September 17, 2025

City of Parker
Engineering Department
20120 East Mainstreet
Parker, CO 80138

DRAINAGE MAP
HUNTINGTON NATIONAL BANK
LOT 3A PARKER POINTE SUBDIVISION FILING NO. 1, AMENDMENT NO. 1, LOCATED IN THE NORTHEAST 1/4 OF SECTION 3, TOWNSHIP 6 SOUTH, RANGE 66 WEST OF THE 6TH P.M., TOWN OF PARKER, COUNTY OF DOUGLAS, STATE OF COLORADO

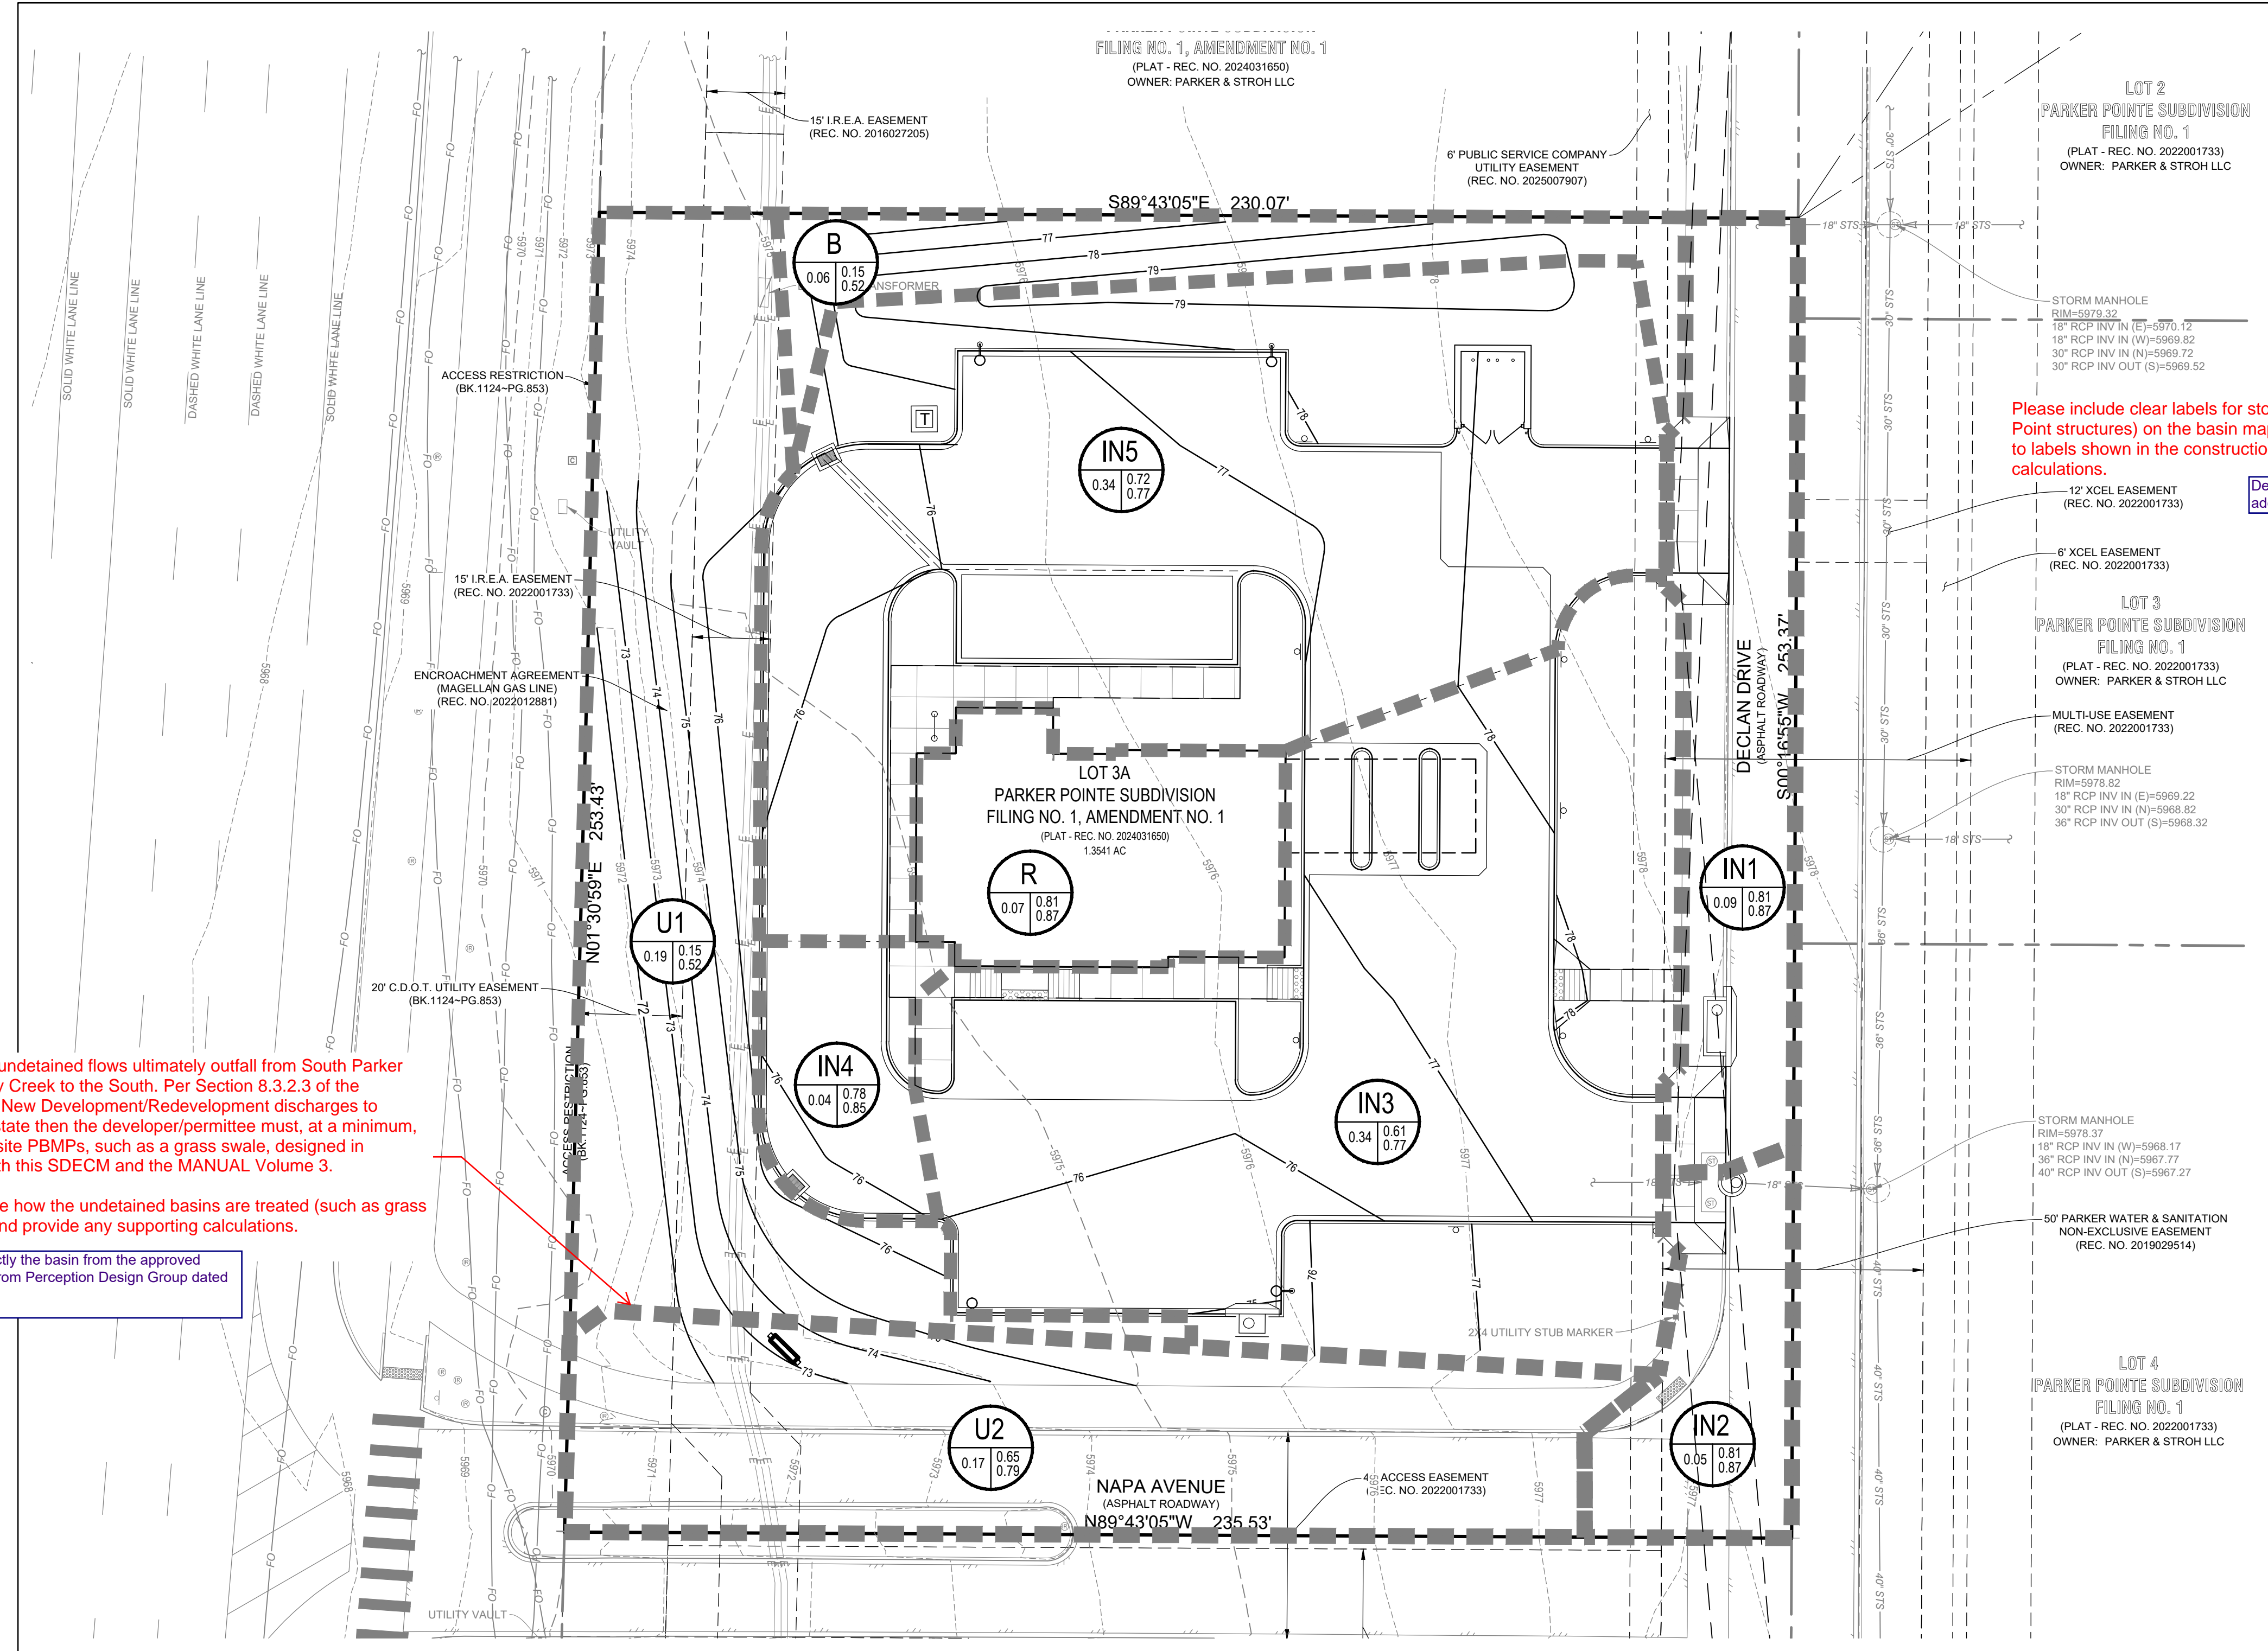
Please include clear labels for storm inlets (Design Point structures) on the basin map that correspond to labels shown in the construction plans and calculations.

The proposed undetained flows ultimately outfall from South Parker Road to Kinney Creek to the South. Per Section 8.3.2.3 of the SDECM: If the New Development/Redevelopment discharges to waters-of-the-state then the developer/permittee must, at a minimum, implement on-site PBMPs, such as a grass swale, designed in accordance with this SDECM and the MANUAL Volume 3.

Please describe how the undetained basins are treated (such as grass buffer areas) and provide any supporting calculations.

Design point labels added to the map.

U2 matches exactly the basin from the approved drainage report from Perception Design Group dated November 2018.

Project: **Huntington National Bank**
 Inlet ID: **Inlet 3**

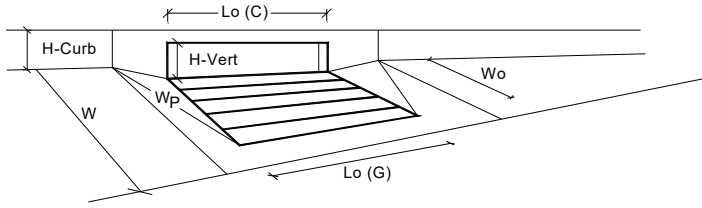
Per the Town of Parker SDECM Section 6.3.1 for Street Drainage use Mannings n for street=0.016 (Typical)

Mannings number revised to be 0.016 on all sheets.

DRAINAGE PLAN WEST

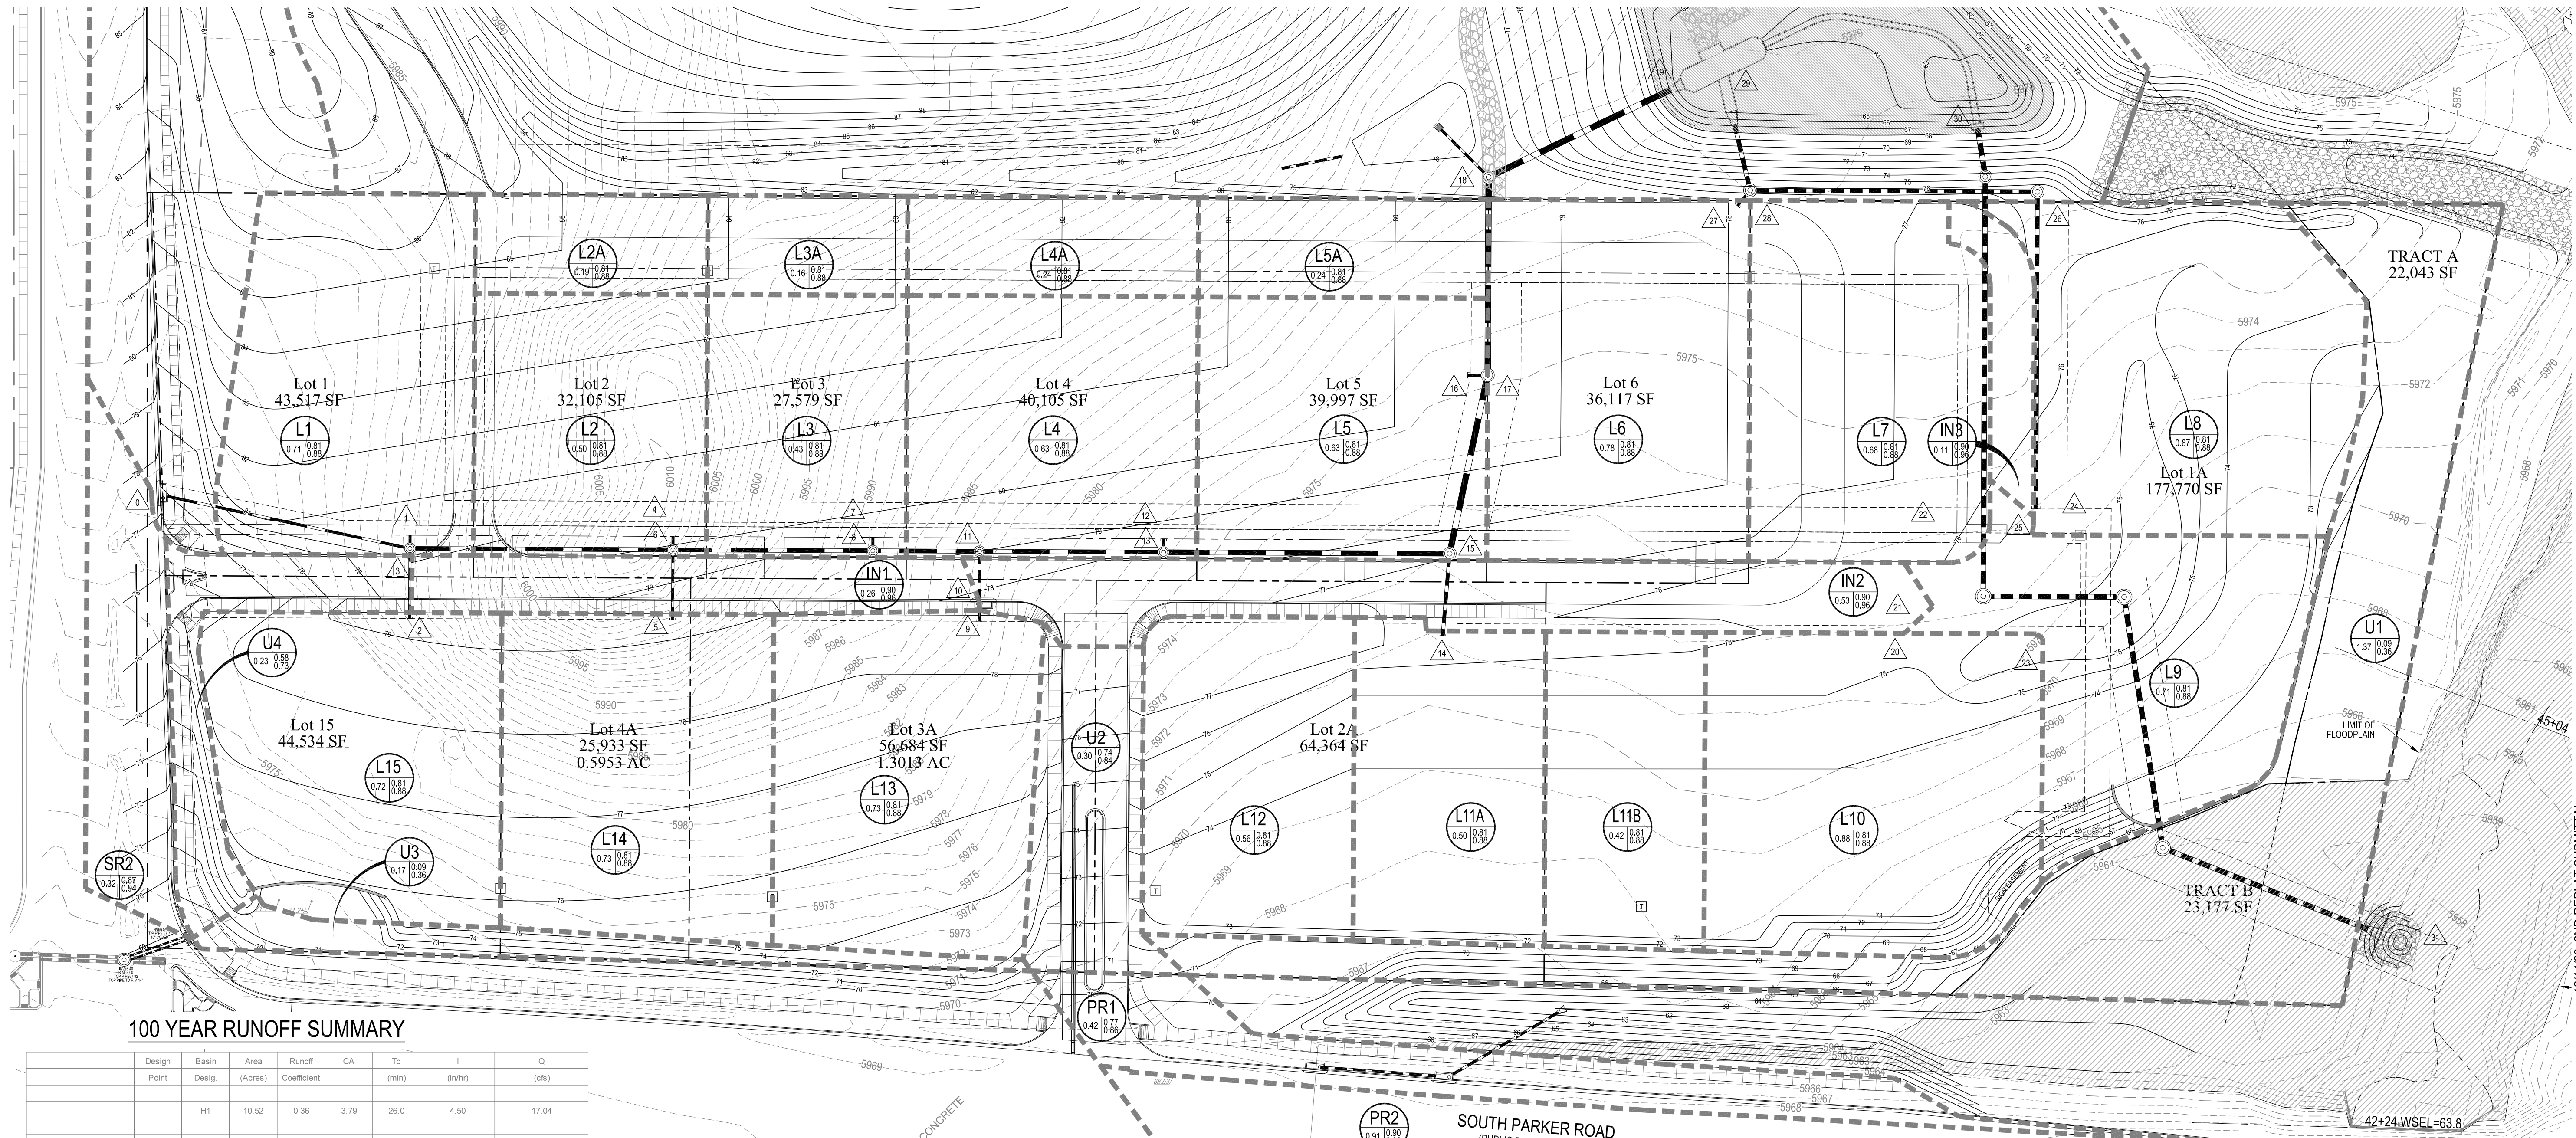
Please include hydraulic calculations for pipe sizing and HGL's for the minor and major storm events. (See Section 6.3.3.4 of the SDECM for Hydraulic Design Requirements)

This sheet is from the original report the pipe sizing and HGLs for the proposed pipes are under the table called Mannings. Report revised to be cleared what is from the original report.
